FINAL DRAINAGE REPORT

**UTE PASS STORAGE
8775 W. HIGHWAY 24, CASCADE, CO**

February 15, 2018
Revised October 23, 2018

**JPS Project No. 111704
PCD Project No. PPR-18-028**

HORZ. SCALE: 1"=20'	DRAWN: BJJ
VERT. SCALE: N/A	DESIGNED: JPS
SURVEYED: RIDGELINE	CHECKED: JPS
CREATED: 2/02/18	LAST MODIFIED: 10/23/18
PROJECT NO: 111704	MODIFIED BY: BJJ
SHEET: D1

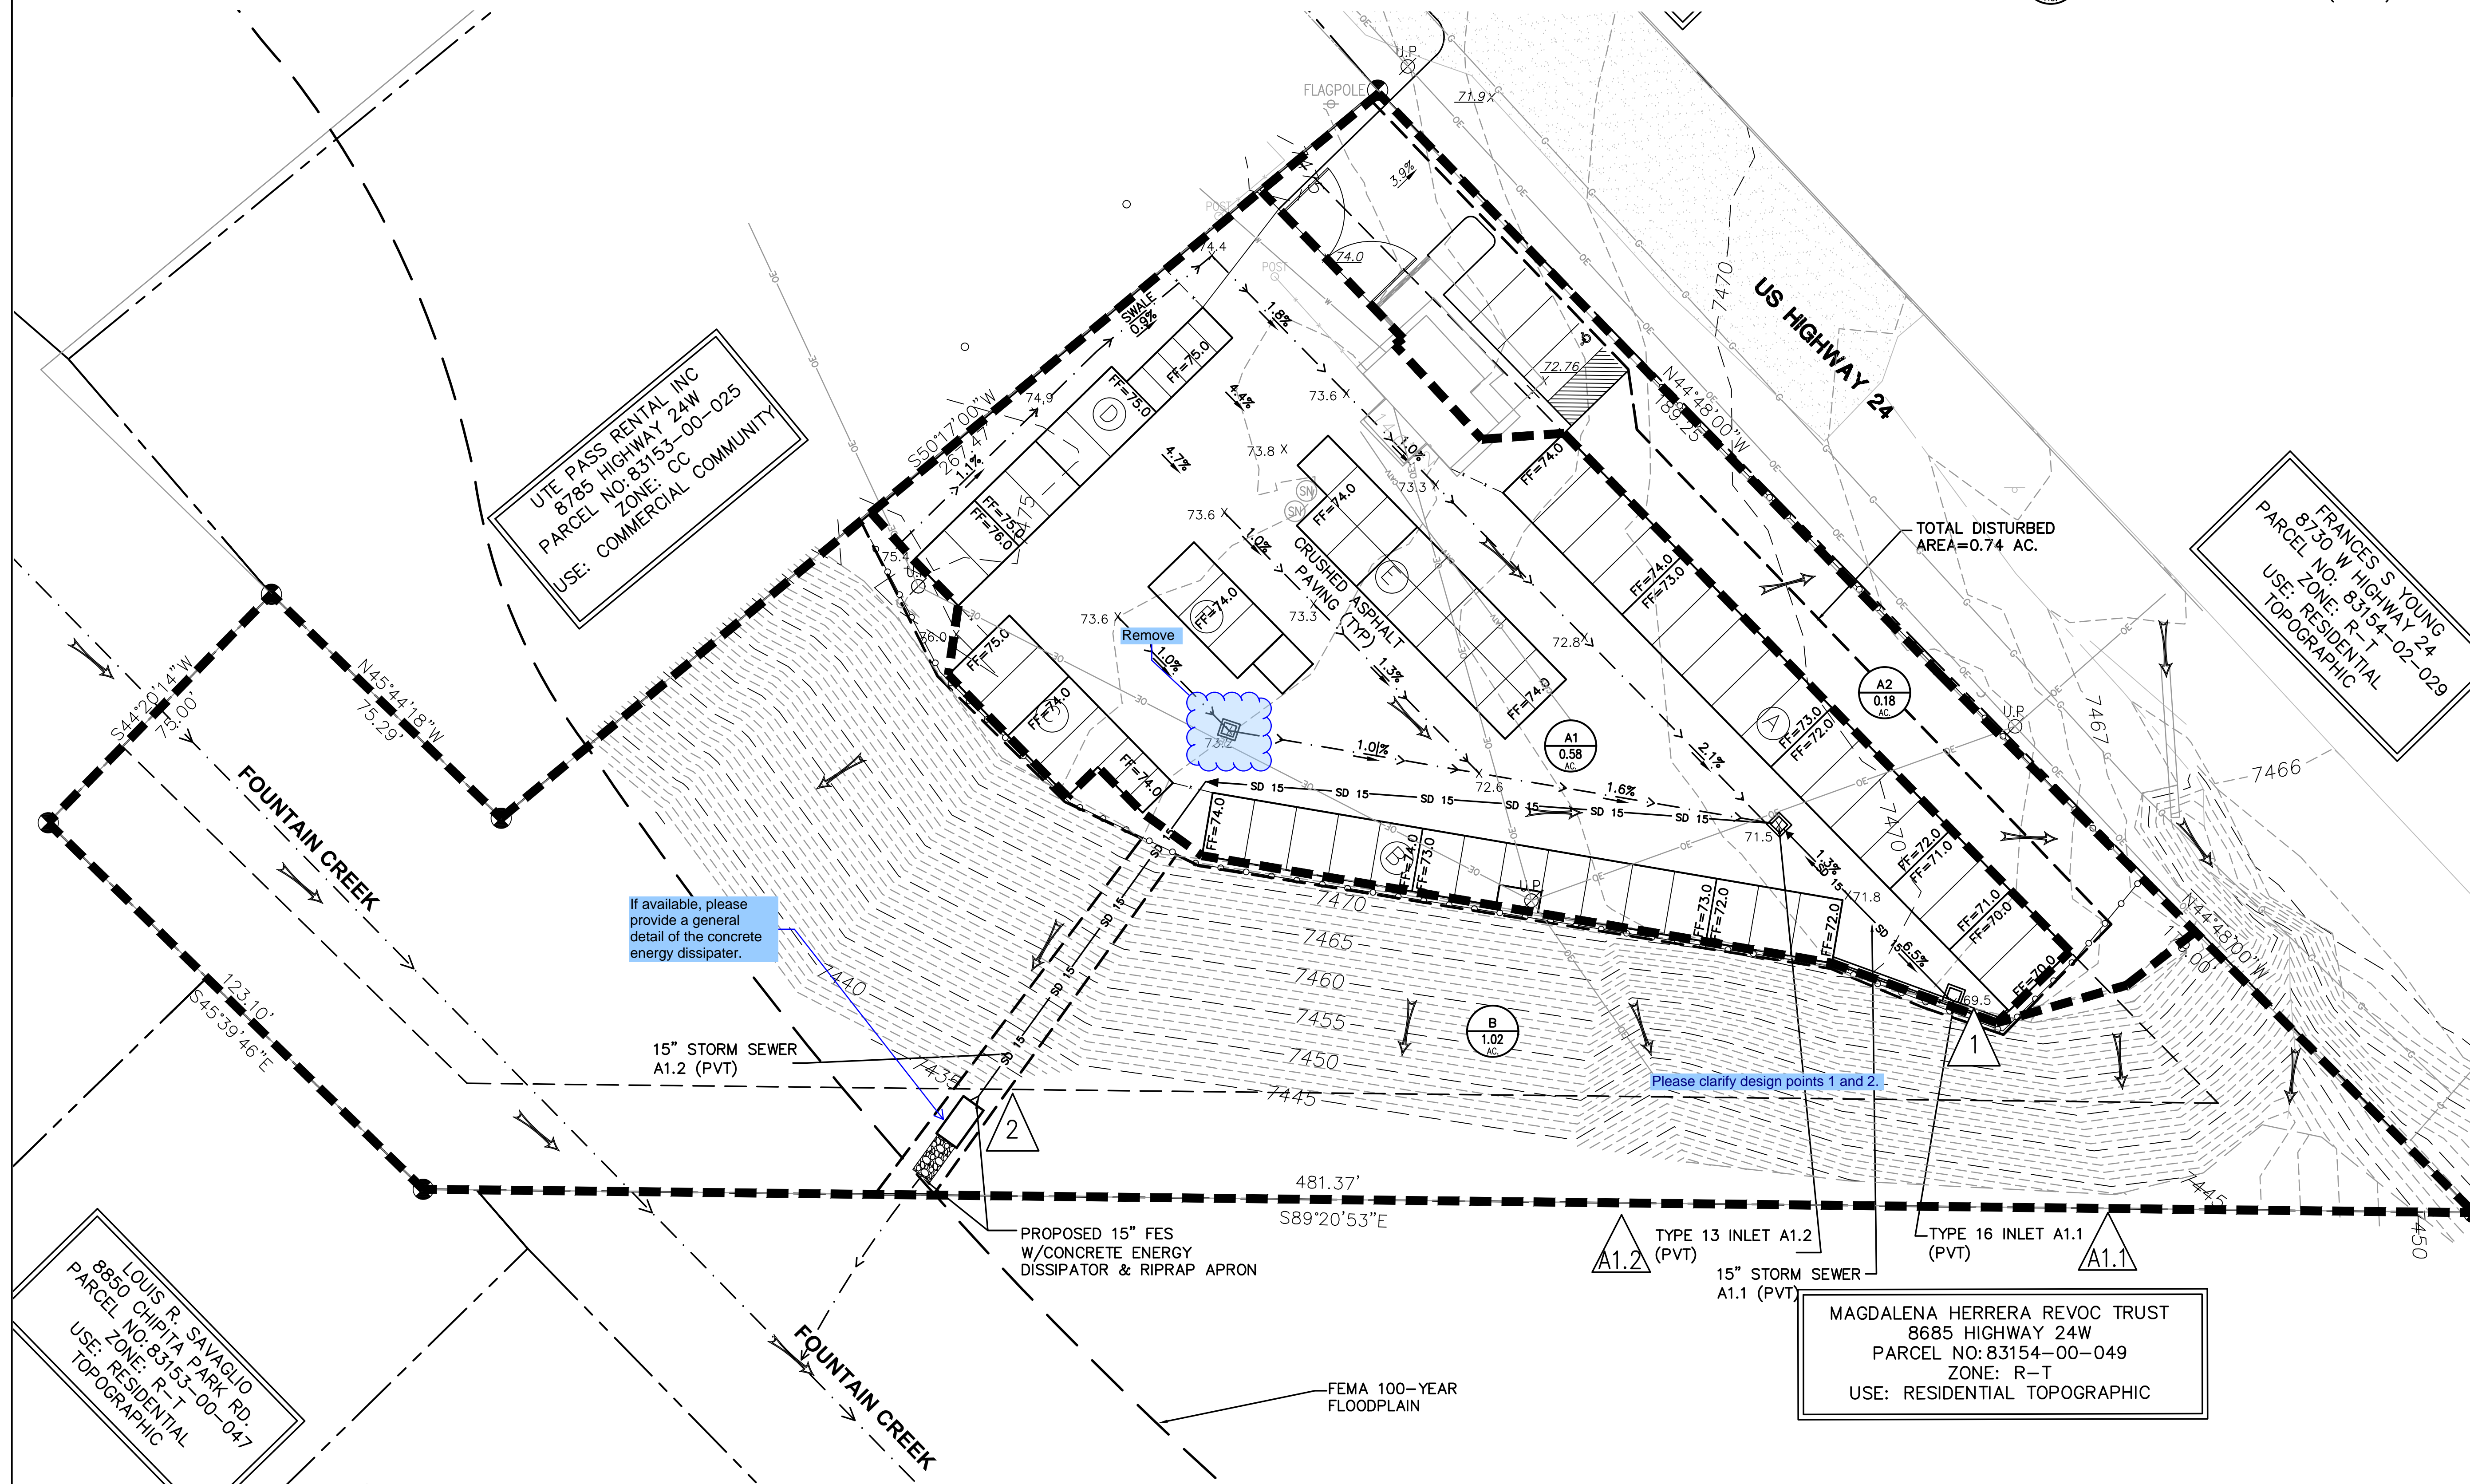
Please show on the drainage map where design points A1 and A2 are located.

This statement does not appear to make sense. Based on the drainage map design point #1 is located in the southeast corner of sub-basin A1. Flow from sub-basin A1 discharges at design point #2 at the toe of the south embankment. It doesn't look at the flows from sub-basins A1 and A2 combine at design point #1. Is design point #1 supposed to be located at the southeast corner of sub-basin A2, just before discharging into the existing channel? Revise this drainage letter to more accurately reflect the drainage map, where applicable.

Please clarify design points 1 and 2.

If available, please provide a general detail of the concrete energy dissipater.
